PROJECT: Addison Airport
 Addison Airport US Customs and Border Protection Facility
 JC Commercial – Change Order No. 3

Change Order Number: 3

Project Name: Addison Airport US Customs and Border Protection Facility

Re: Narrative for Proposal #24-24a – Wall Adjustments (Drywall)(Revised)
Project No: 417151

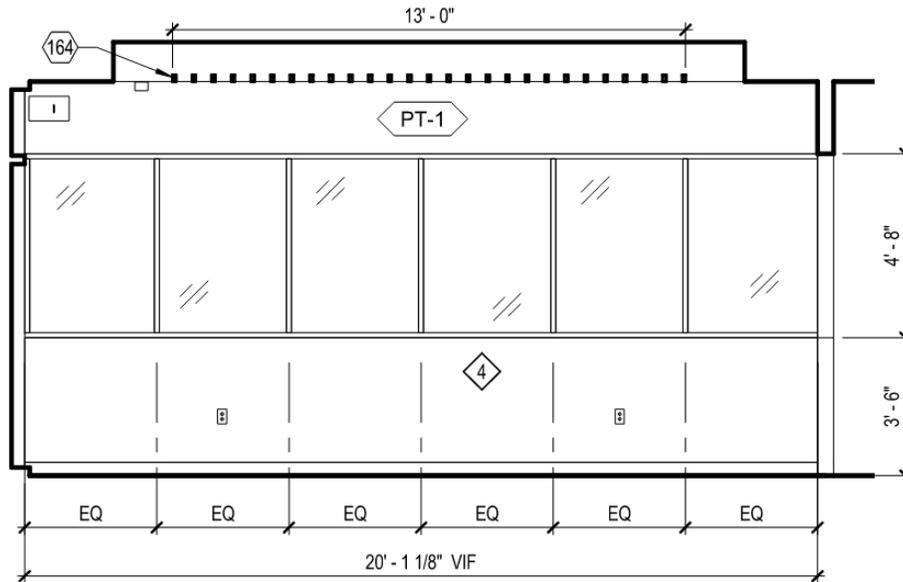
Proposal #31 was the result of on-site coordination and discussion between the drywall subcontractor, JC Commercial’s Superintendent and the Architect. During a site visit the drywall subcontractor directed the Architects attention to the framing he had completed for the walls shown below in an extract from the floor plans shown on sheet A-101:

These walls have glass and aluminum framing that takes up the top half of the wall which does not allow the stud framing to run continuously from floor to deck above which compromises is integrity. See interior elevation shown below from sheet A-211 for quick reference:

The wall support elements were installed below the windows inside the 3'-6" tall section of drywall framing to brace the wall from overturning/folding if a lateral force is applied to it in the middle of the wall.

Subject: Proposal #38 - Credit for RFI #083 (Northwest Light Pole Removal) Category: Proposal

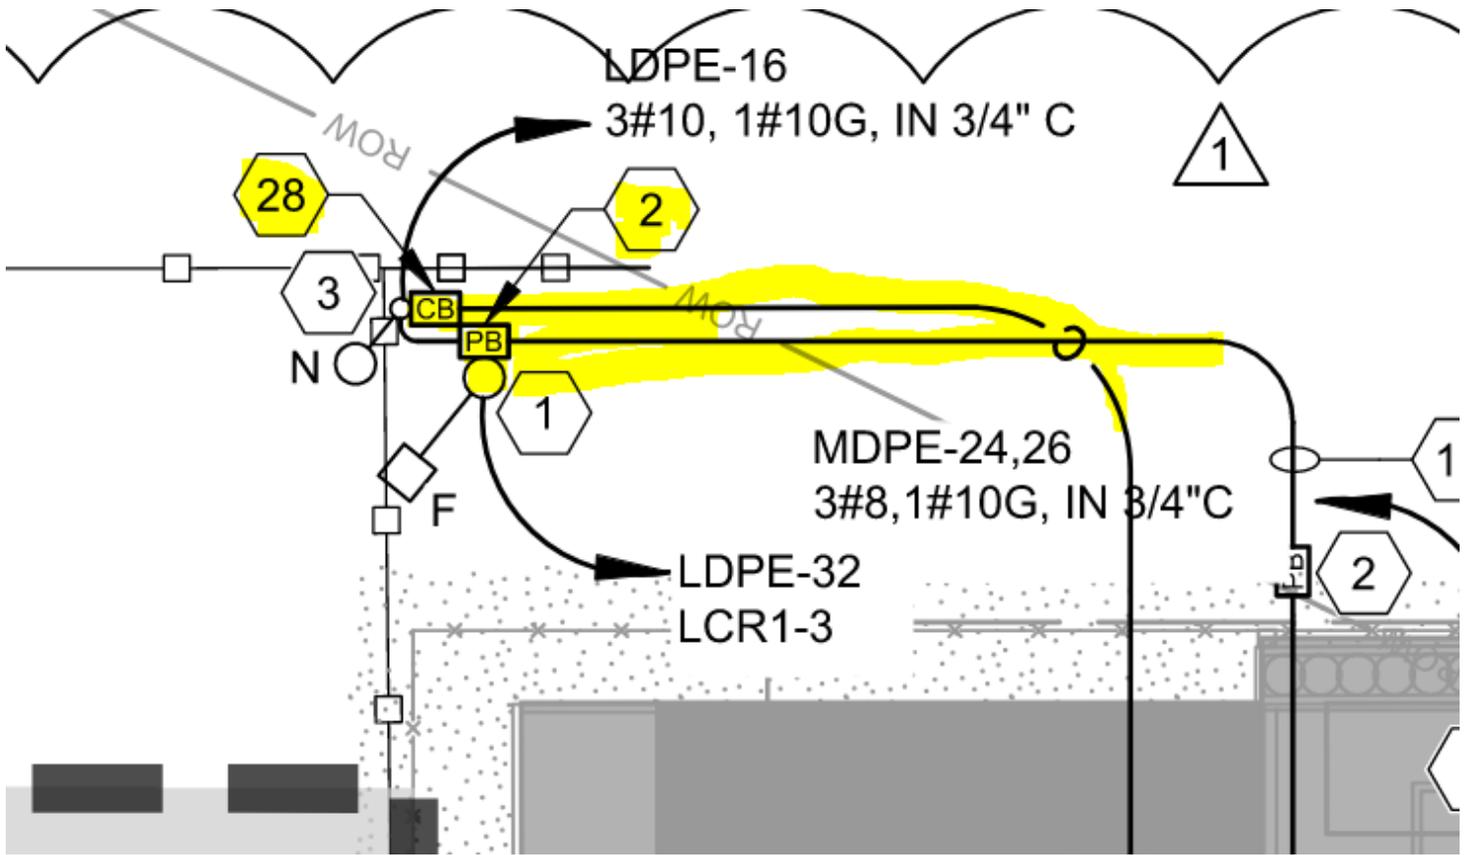
Per the response to RFI #083, we are proposing a credit of \$712.00 to remove the light pole base in question from our scope. Please be aware that if the light pole base in question is not installed by the time our electrician is ready to install his light poles, there will be an additional remobilization fee that will be charged to the owner for the electrician to make an additional mobilization to the site to install only one light pole.
